XT308-02

TECHNICAL BULLETIN

Clutch Pedal Sticking Down –
Install Additional Spring –
Repair

MODEL 2002 MY-ON
X-TYPE
VIN C00001-ON

ILLUSTRATION 1

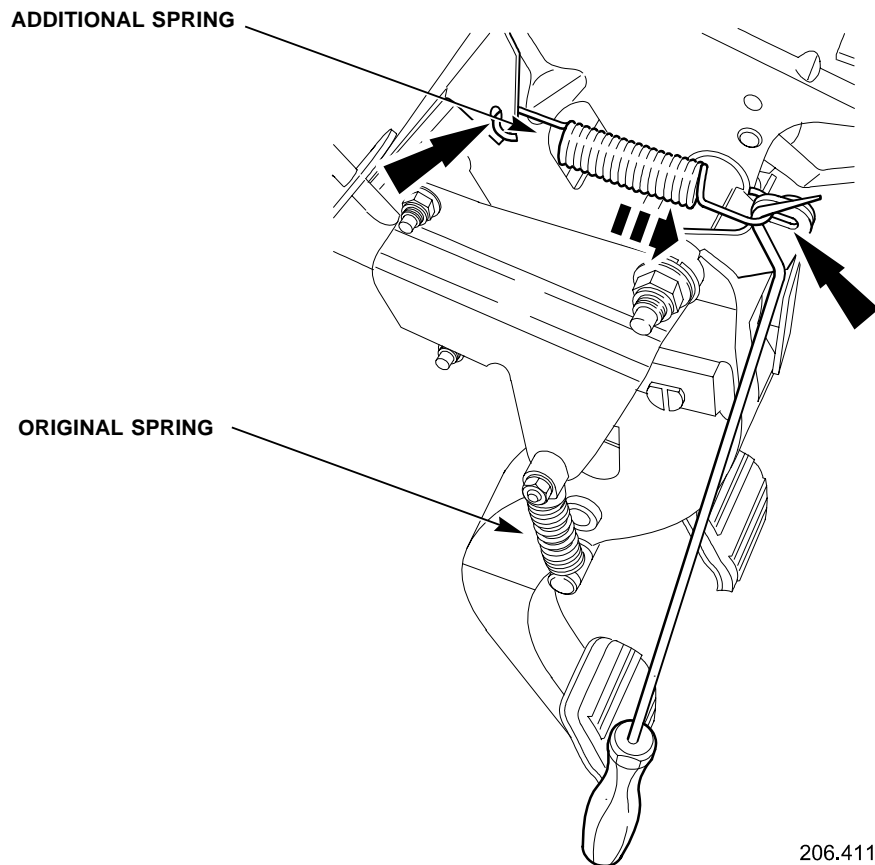
On some 2002 MY-ON X-TYPE vehicles with manual transmissions, customers may complain that the clutch pedal will stick in the down position intermittently, and will not return unless lifted manually.

A new spring has been released that can be installed in addition to the existing spring, in order to alleviate this concern.

3. Install one end of the new spring to the clutch pedal housing bracket. Install the other end of the new spring to the clutch pedal bracket (Illustration 1).

Note: A suitable tool ('Snap On' A1710 or similar) will be required to aid with the installation of the new spring to the clutch pedal. The tool should be long enough to be used by both hands to generate enough force to expand the spring.
